SAM G51 Series Family Silicon Errata and Data Sheet Clarification

Data Sheet Clarifications

The following typographic corrections and clarifications are to be noted for the latest version of the Device Data Sheet (Atmel-11209D-ATARM-SAM-G51G-SAMG-51N-Datasheet_19-Nov-14).

4. Module: Transmitter Operations

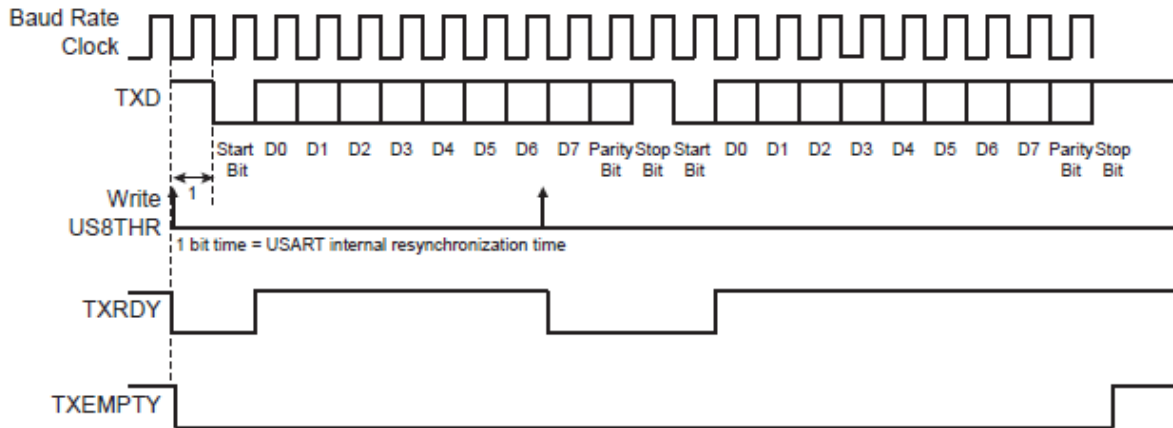
Figure 31-5 is incorrect, and the amended figure is as follows:
